SERVICE PROCEDURE

**G-08506
OCTOBER 2008**

**SUBJECT: SAFETY RECALL (U.S.)
IDM FUSE BLOCK on certain INTERNATIONAL®
3200, 3300, and IC Bus BE, CE, HC, RE models
built 9/21/01 thru 12/31/07 with an
INTERNATIONAL® VT-365 engine.**

Figure 1.
Battery Interconnect Cable

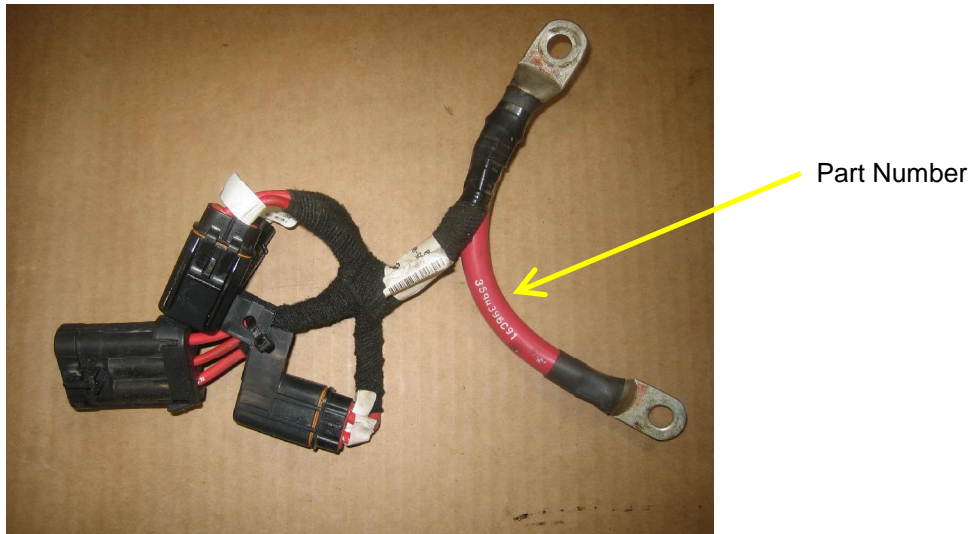
The vehicle may exhibit engine hard start, no start, or stall conditions due to damaged terminals in the fuse holder connector for the injector drive module (IDM) clean battery power circuit. In bus applications, the evacuation and containment concerns relating to multiple passengers may result in an unreasonable risk to motor vehicle safety.

- a. Inspect the part number printed on the vehicle's battery interconnect cable with integrated clean circuits. Figure 1 shows the cable.

- If the vehicle is equipped with an interconnect cable that is identified as an “old part number”, then it will need replaced with the associated “new part number”.
- If the vehicle is equipped with an interconnect cable that is identified as a “new part number”, do not order a replacement cable.

Figure 4. Engine Clean Power Connector

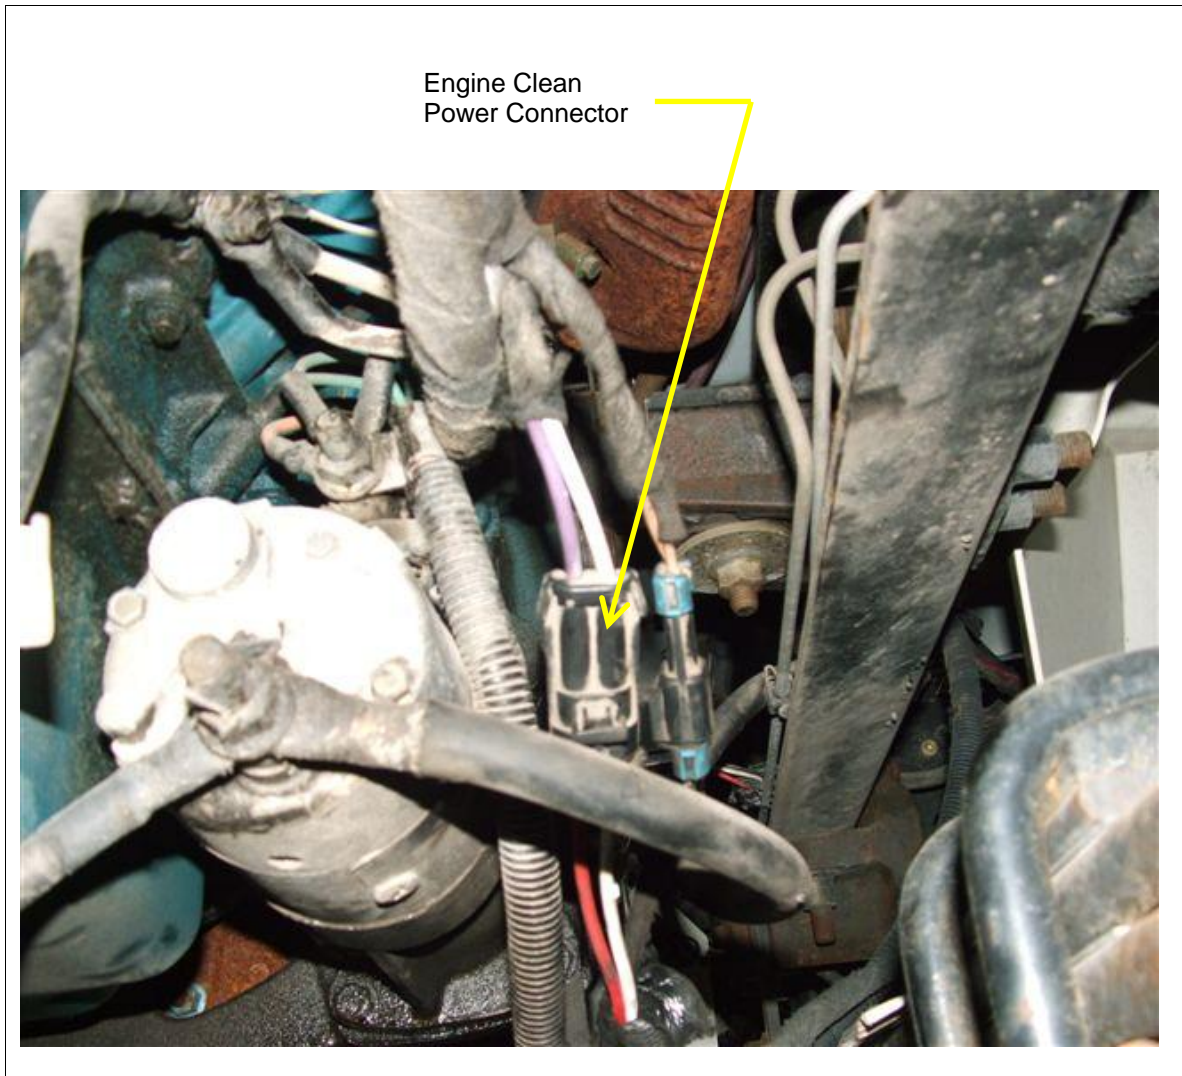
- Table 2 indicates connector cavity, markings, wire size and wire color.
 - See Figure 4 for assistance.
- b. Remove tie straps and tape on the harness as needed to access connector.
 - c. Remove connector by cutting the four wires at the connector.
 - d. Strip the insulation back ¼” from the ends of all four wires.
 - e. Place a 2” piece of double wall heat shrink tubing on either the violet or red wire. Place another 2” piece of double wall heat shrink tubing on one of the white wires.

Figure 6. Harness Splice Sealed With Heat Shrink Tubing

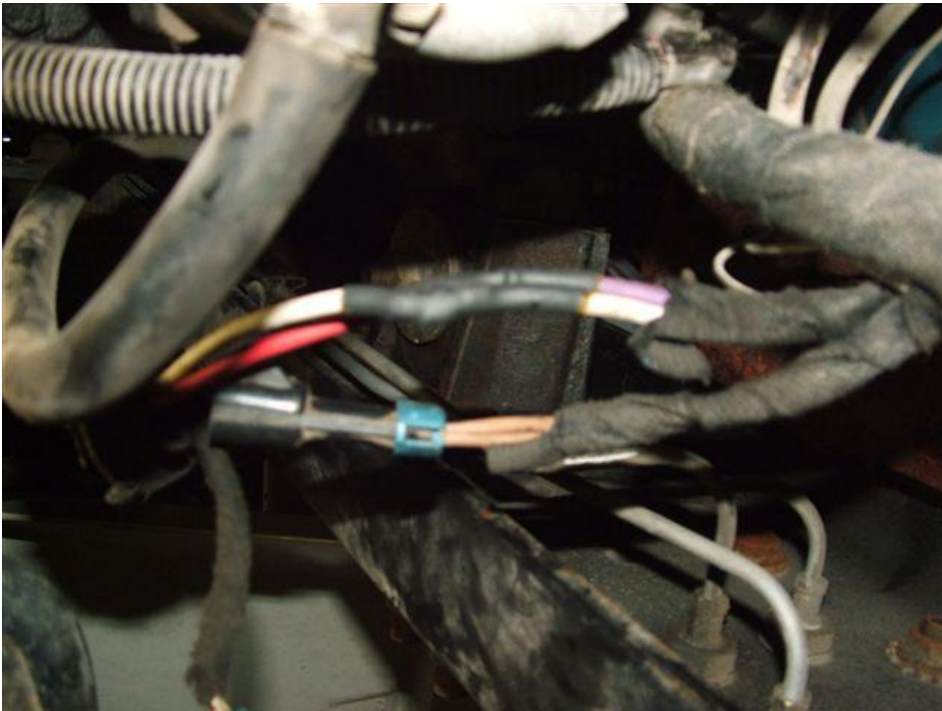
- a. Connect the violet wire and the red wire by crimping on a splice. Connect the two white wires by crimping on a splice. Make sure all the individual wire strands are inside the crimp splice.
- b. Solder (60/40 rosin core) both connectors into the crimp splice. Make sure the solder and conductor are hot enough to allow the solder to “flow” into the individual conductors of the wire and the inside of the crimp splice. Figure 5 shows the connections crimped and soldered.
- c. Slide the double wall heat shrink tubing over the crimp splices and apply sufficient heat to shrink the tubing over the connector and wires. Make sure the tubing is centered over the crimp connector prior to applying heat. Figure 6 shows the splice connection sealed with the heat shrink tubing.
